**Amendments to the Drawings:**

### **REMARKS**

FIG. 1

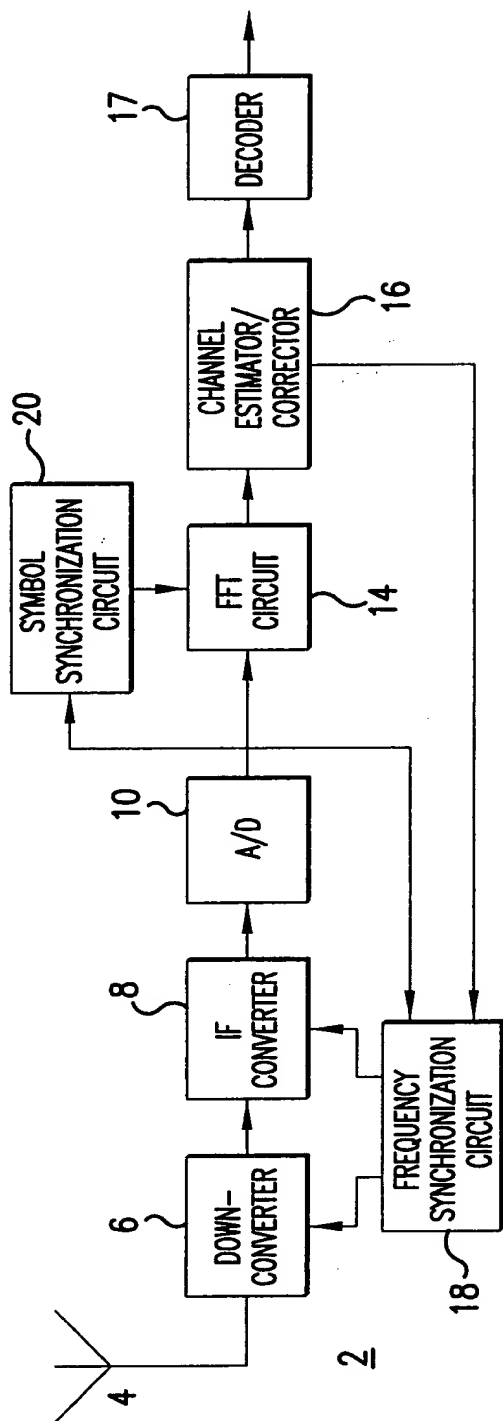
The Office Action states that the demodulating and synchronizing step are not mentioned in the specification. The demodulating step is performed by the apparatus of Figure 1, and the synchronization step by the block 20, as described on page 4, line 15 to page 5, line 12. The Examiner has requested Applicant to label Figure 1 as "prior art". Although the drawing is applicable to the prior art, it is equally applicable to the present

invention if the techniques described with reference to Figure 3 are used in block 20, as specified on page 5, lines 13 to 15.

FIG. 2

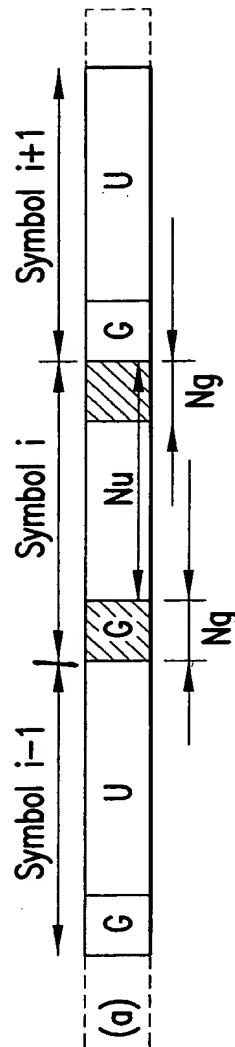
The attached sheets of drawings include changes to Figs. 2 and 3. These sheets, which include Figs. 1-3, replace the original sheets including Figs. 1-3. In Figure 2, a boundary line has been inserted as requested by the Examiner. In Figure 3, a descriptive label for block 24 has been amended to read "DELAY CIRCUIT" and a descriptive label for block 30 has been amended to read "MULTIPLIER". Replacement drawing sheets and annotated drawing sheet are attached. The annotated drawing sheets indicate the changes in red ink.
